ICHD - ENVIRONMENTAL HEALTH DIVISION

SEPTIC: IMPROVEMENT PERMIT / AUTHORIZATION TO CONSTRUCT / OPERATION PERMIT / EXISTING SYSTEM

Notice of Intent to REVOKE Improvement Permit/Construction Authorization

Subject: Notice of Intent to Revoke: Address : 156 Direct Dr, Mooresville, NC 28117 Permit 323531 (Improvement Permit/Construction Authorization

INITIAL SITE SKETCH

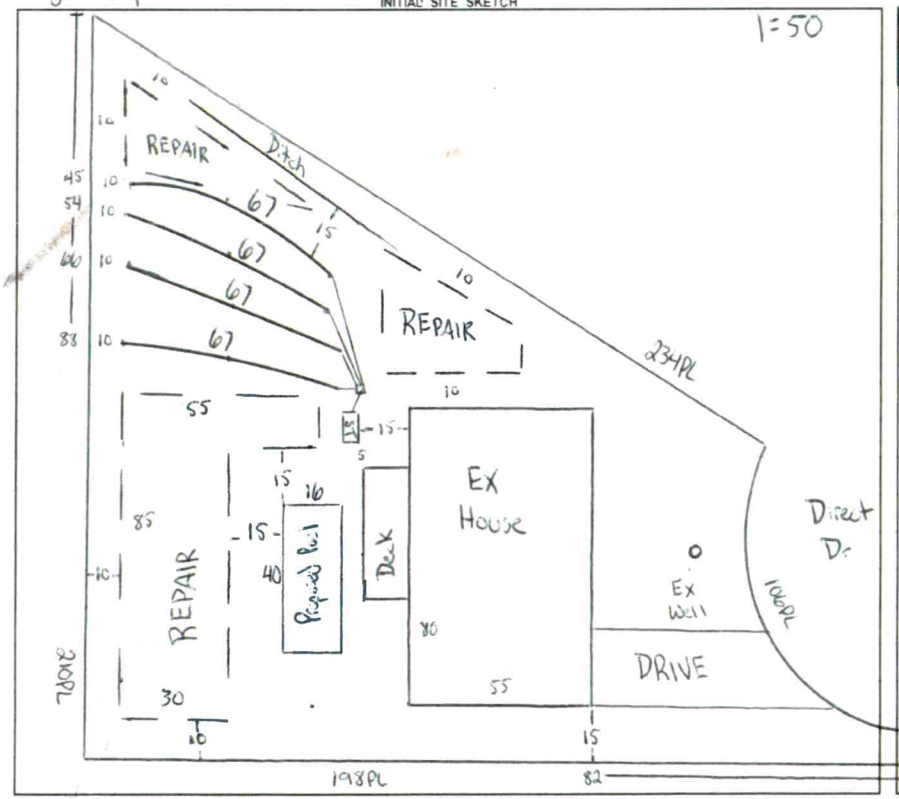
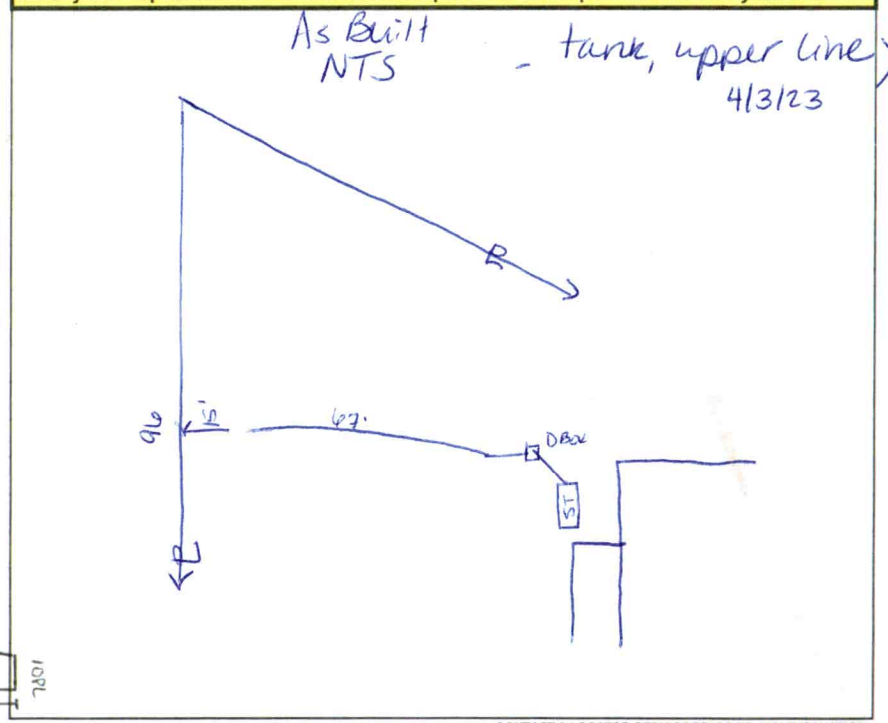
Comments / Conditions: Install drainlines on contour with the land. Do not exceed max of 28" or will be SAP controlled. Do not grade, park, or drive on septic area.

5" of ICHD cover will be required. Ditch must be removed prior to OP.

INITIAL SITE SKETCH

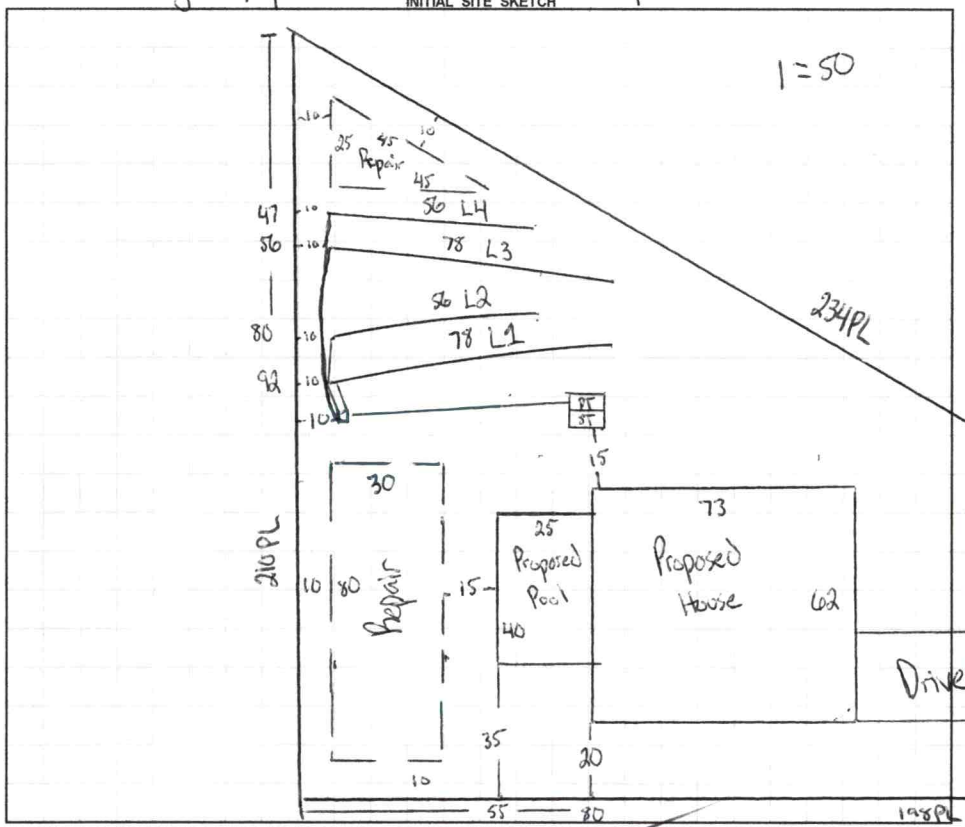
Comments / Conditions: Install drainlines on contour of the land.
Do not exceed max of 28 inches or will be SAP system.
Do not grade, park, or drive on septic area.

5" of ICHD cover will be required
